Marginal Coverage Contribution of the Proposed Tower

Conditional Use Permit CU-26-001 — Sandoval County, NM

File: CU-26-001 — Proposed 75-ft monopole at 221 NM-165, Placitas NM 87043 (APN 102-307-302-8180)

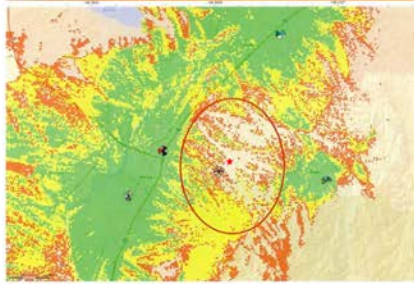
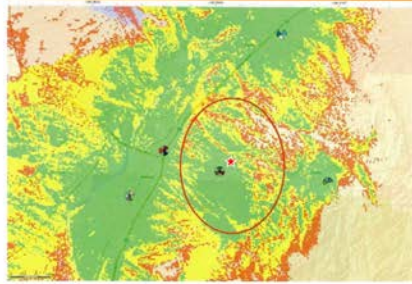
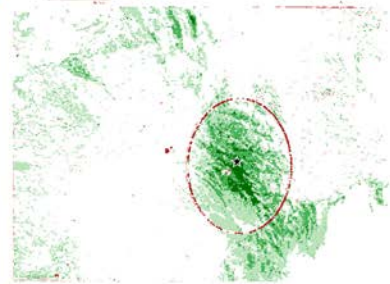
Figure 1 presents the two applicant-submitted rasters side-by-side with the computed marginal-contribution panel on the right. The proposed tower location is marked with a star in all three panels; the applicant's drawn coverage-objective ellipse is preserved in red on the marginal panel for reference.

The difference map makes visible what the applicant's two aggregate rasters present only by implication: the geographic distribution of the proposed tower's marginal signal contribution. The result is consistent with the published propagation physics of a single 75-ft monopole sited at the proposed location:

The marginal-contribution map in Part IV shows substantial modeled coverage benefit into locations Part II independently identified as geometric-shadow zones. The mechanism by which that benefit accrues in the applicant's model is non-line-of-sight propagation. The standard-default parameter values for diffraction, reflection, and scattering used in commercial RF-planning tools are calibrated to environmental conditions that depart from Placitas in every one of the five physical respects documented in Section 3 of this supplement. The proper inference from this fact pattern is not that the proposed tower will produce no coverage benefit in shadowed areas — diffraction and scattering are real propagation mechanisms — but that the

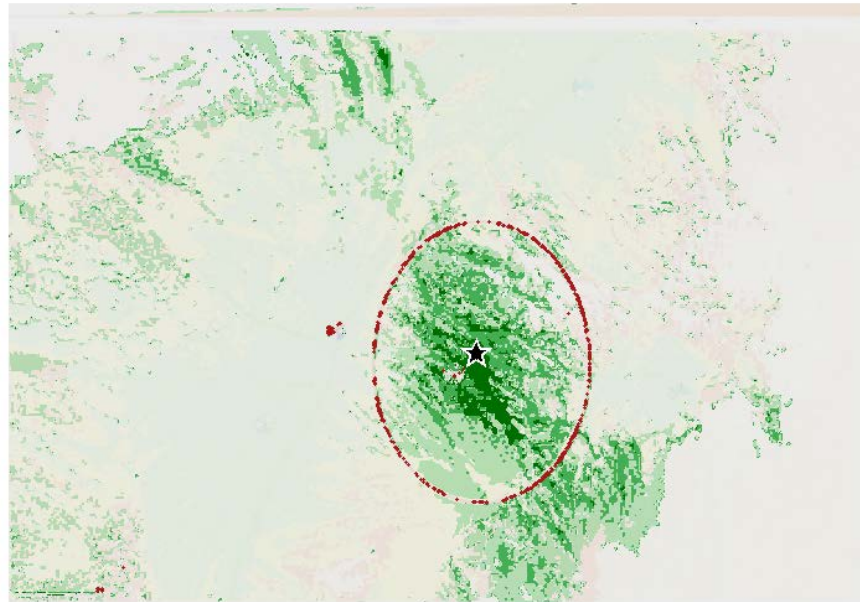
Figure 2 magnifies the marginal-contribution panel and overlays it on a desaturated topographic backdrop so the geographic context (drainages, ridges, road network) remains visible.

The marginal-contribution map is presented here in geographic, not demographic, terms. A separate analysis would be required to weight the improved cells by residential parcel density. However, two qualitative observations are clear from Figure 2:

Proposed Placitas Cell Tower Adds Minimal Coverage for Verizon Customers

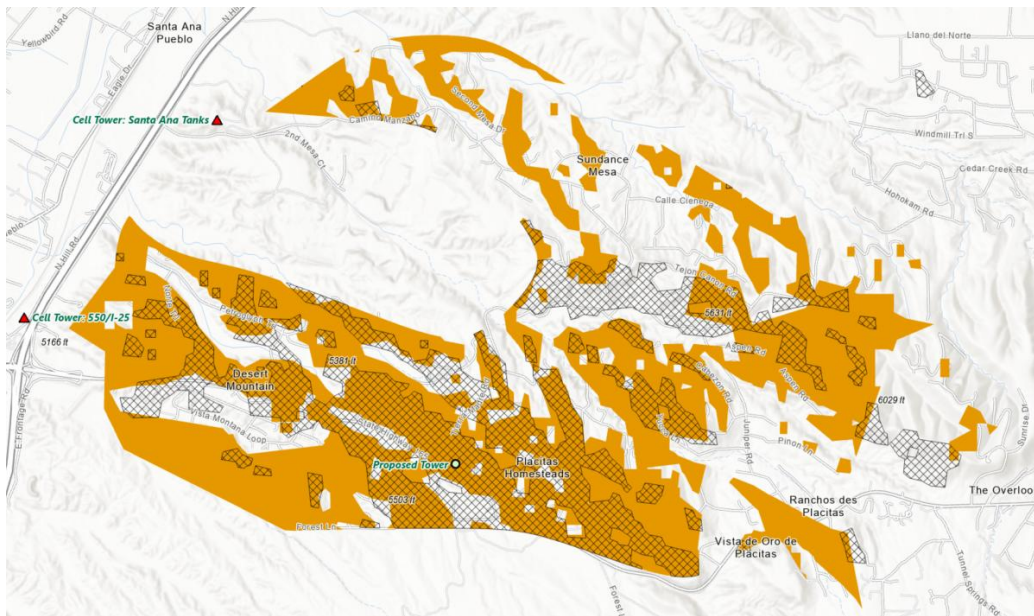
In The Development Narrative Report, the applicant claims that this site is "for the purpose of expanding wireless coverage to the area identified as having high demand for Verizon Wireless Services ..." While coverage would be expanded, it would be by twenty percent, at most.

In the LoS map below, orange depicts the areas of residential western Placitas covered by existing Verizon towers if the Santa Ana Tanks tower was added to the array. Gray hatching shows LoS coverage from the proposed tower. Without the addition of the Santa Ana Tanks tower, the proposed tower would add twenty percent coverage to Verizon's existing footprint in western Placitas. With the Santa Ana Tanks tower, the proposed tower only adds nine percent and still misses large neighborhoods.
